COMMITTEE REPORT

BY THE DIRECTOR OF ECONOMIC GROWTH AND NEIGHBOURHOOD SERVICES
READING BOROUGH COUNCIL
PLANNING APPLICATIONS COMMITTEE: 15th FEBRUARY 2022

Application No.: 200328/OUT

Address: Vastern Court, Caversham Road, Reading

Figure 10: Outline model of the proposed SSE Appeal Scheme amended with Aviva layout (as originally submitted) showing how the North-South Route is indirect with no direct line of sight from the Station to the River

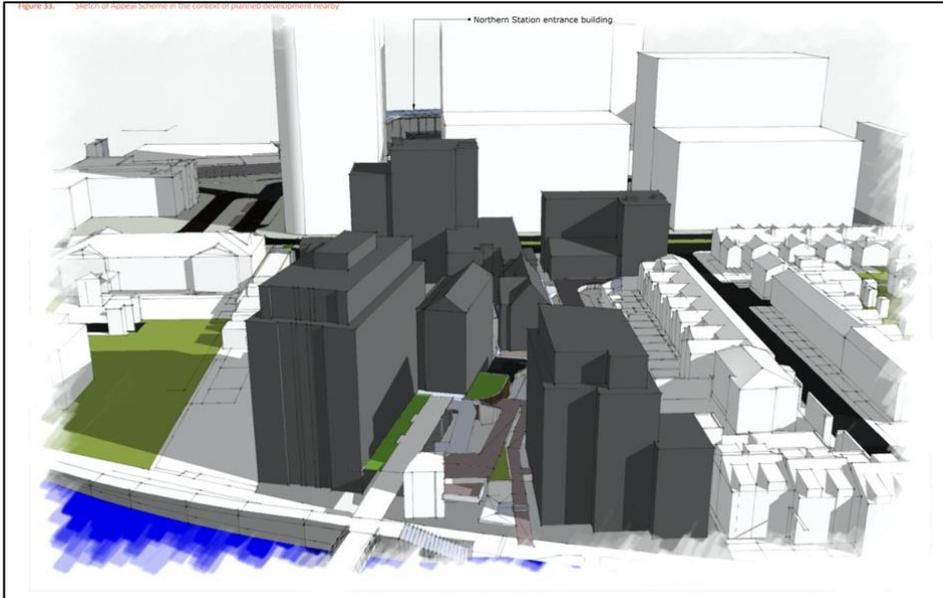
- 8.29 The LPA recognises that the Parameter Plans broadly follow the orientation shown on diagrams in the RSAF and local plan. However, it does not, and possibly cannot take account of the future development of the CR1g site. This would, in turn, lead to a heavily compromised north-south route through the area, which would fundamentally conflict with one of the overarching movement priorities.
- 8.30 Therefore, the development as proposed may prevent the achievement of the high-quality north-south pedestrian and cycle link: This is an essential requirement of policy for this area, through a failure to provide a satisfactory alignment for the connection through the site such as that this compromises the route.

Fig 13 - Tall building location guidance.

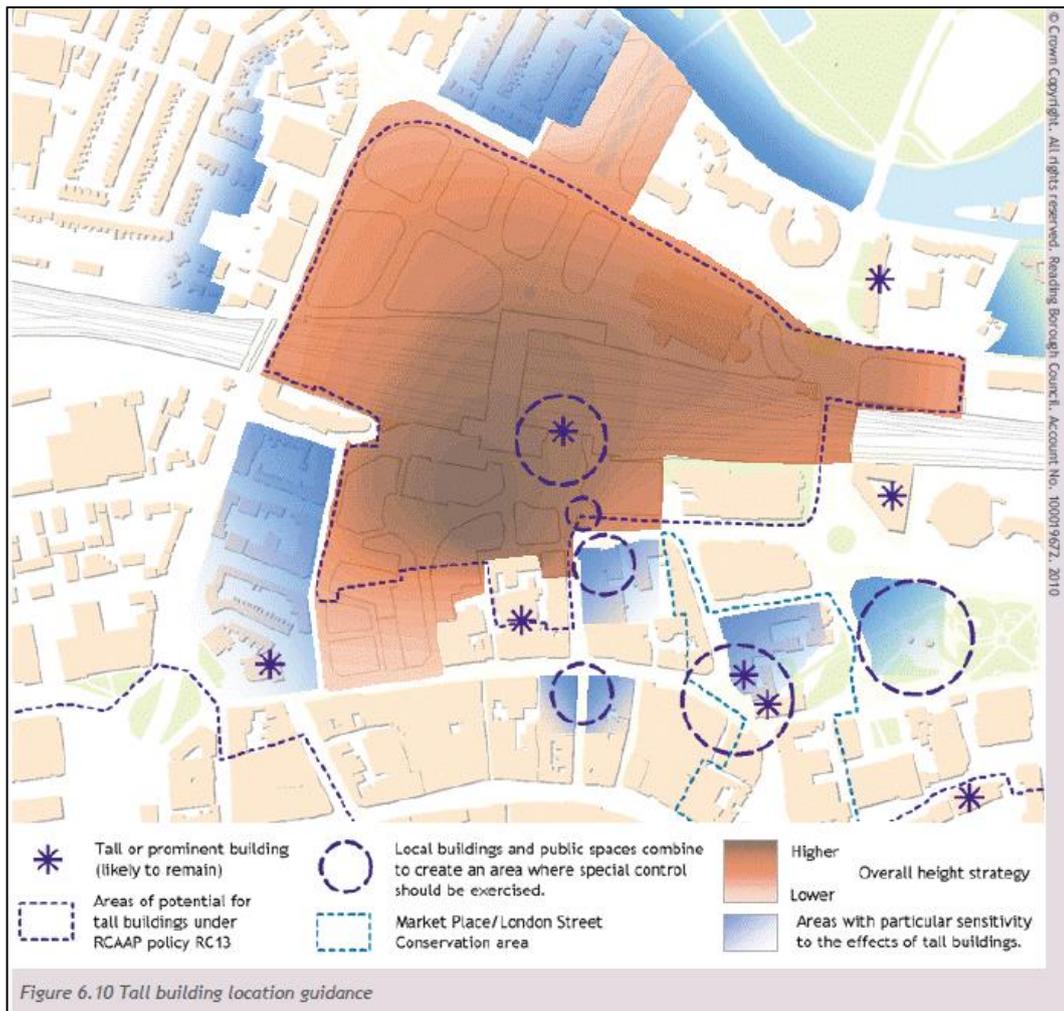
- 8.36 Policy CR10 is clear that the tallest buildings should be close to the station and step down in height from that point toward the lower buildings at the fringes. The policy also requires the creation of a “coherent, attractive and sustainable cluster of buildings with a high-quality public realm”. This cluster extends south beyond the CR11E site allocation to include Station Hill south of the railway. Another key policy requirement of CR10a is that proposals are to “Ensure that adequate space is provided between the buildings to avoid the creation of an overly dense townscape and to allow buildings to be viewed as individual forms”.
